Mixed Industry and Business Development – 101 Wongawallan Drive, Yarrabilba RFI Response

Lot 27 Wongawallan Drive, Yarrabilba
Swept Path Assessment

AMENDED IN RED

Amber 12

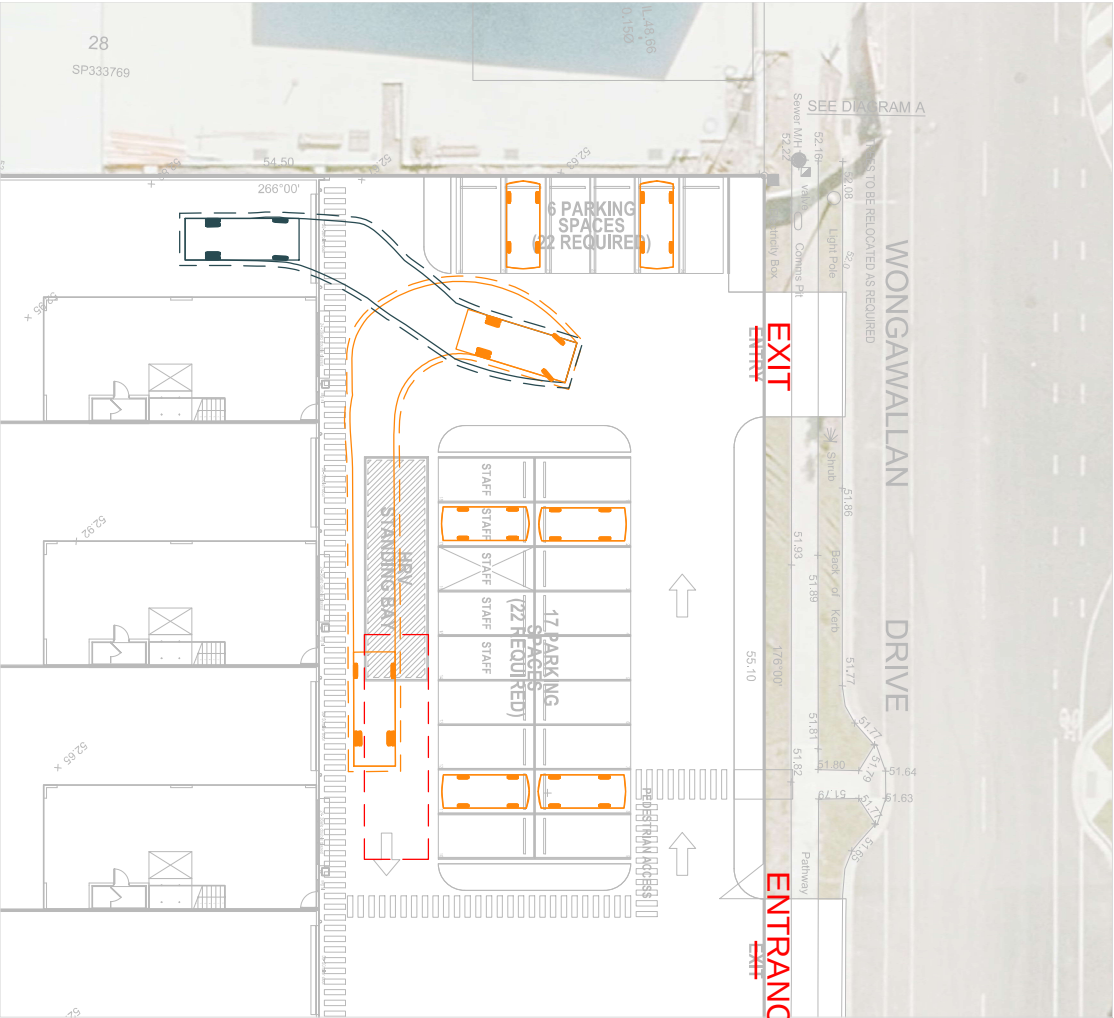
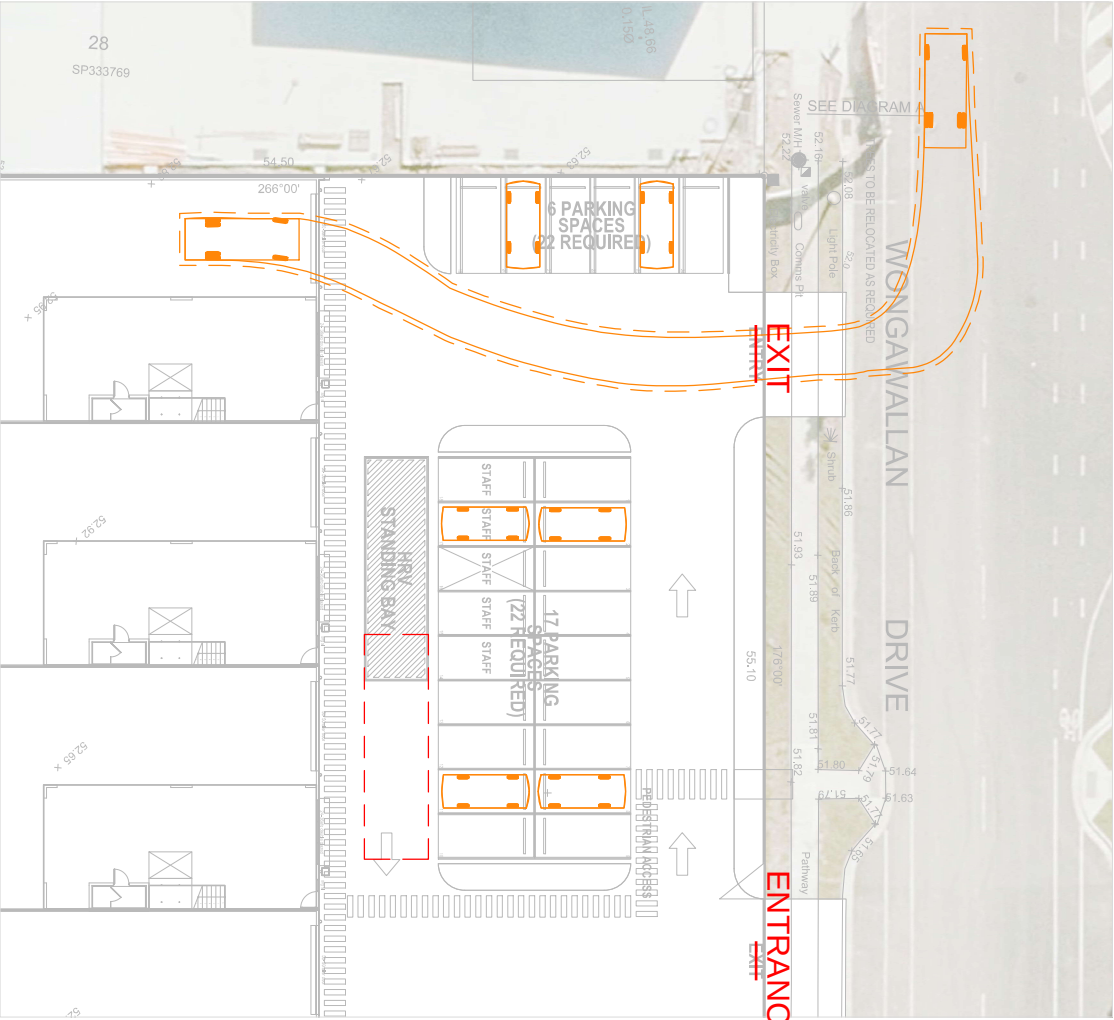
Entry and exit crossovers to be swapped
